PLANT SYSTEMS

ULTIMATE HEAT SINK

3.7.1.3 The ultimate heat sink consisting of two separate and redundant spray ponds and standby service water systems shall be OPERABLE with: DELETE

Safety Evaluation of Standby Service Water Cross-Connection

Standby Service Water Flow Paths

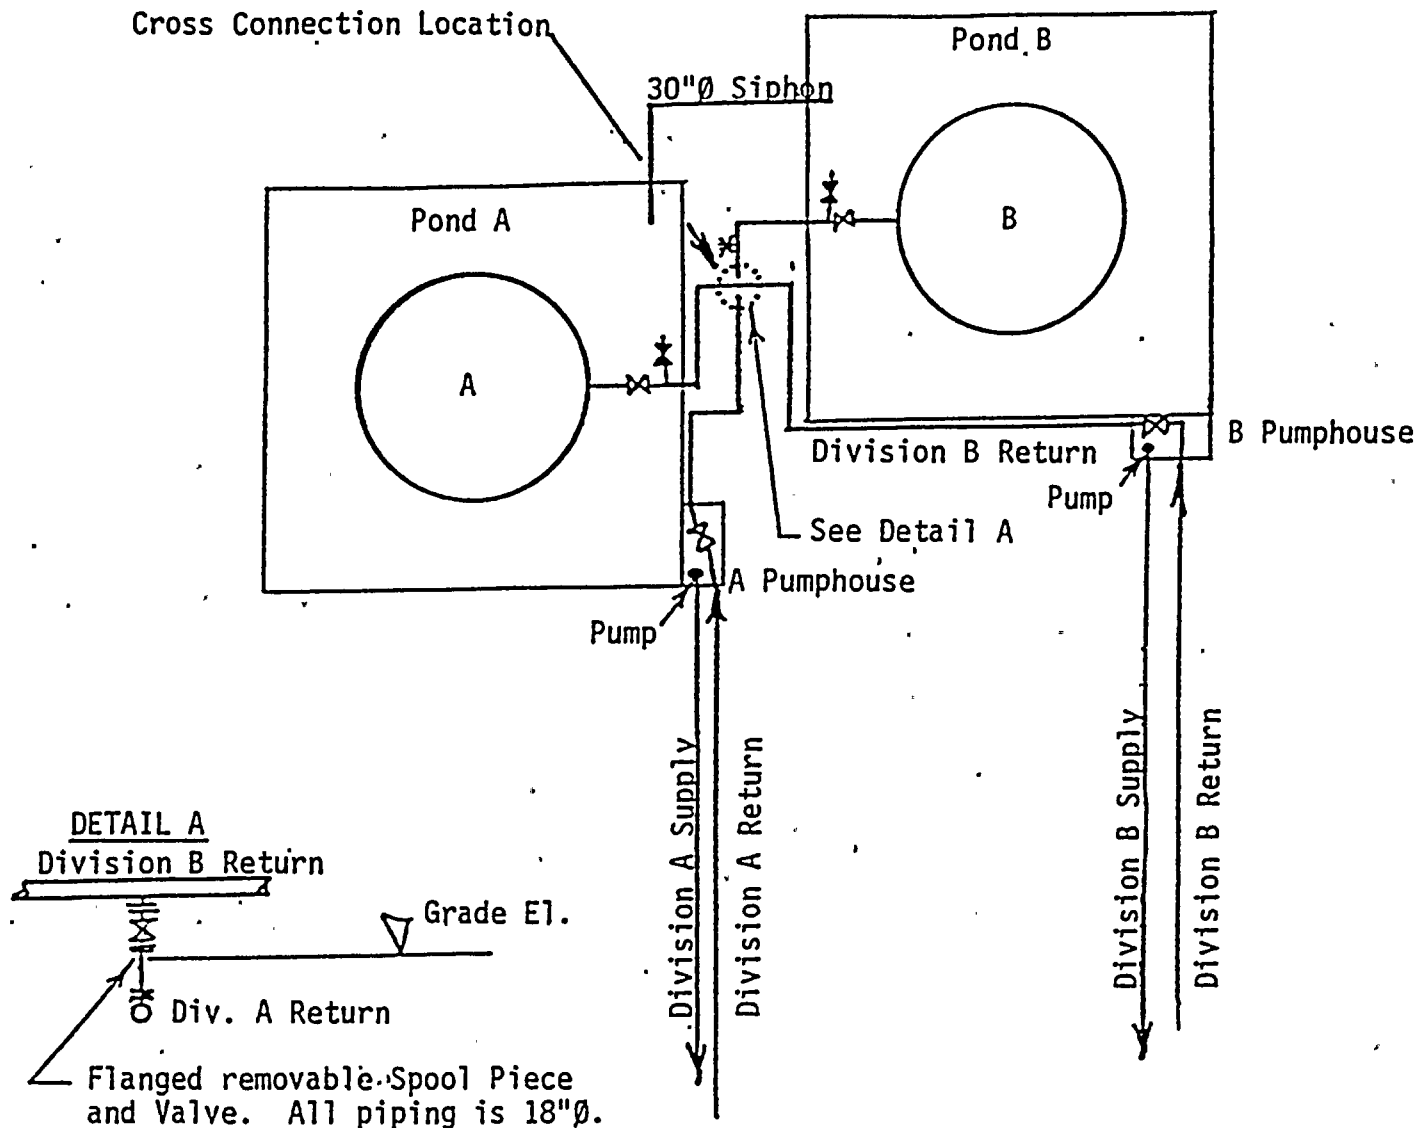
NOTE: Normally spool piece cross connection and valve are removed and connections to return line are blind flanged. During outage when draining a pond (plant in mode "*") the spool piece may be installed to allow aligning valves so B return can go to B pond and vice versa for A.

* Division A Return runs underground between ponds.
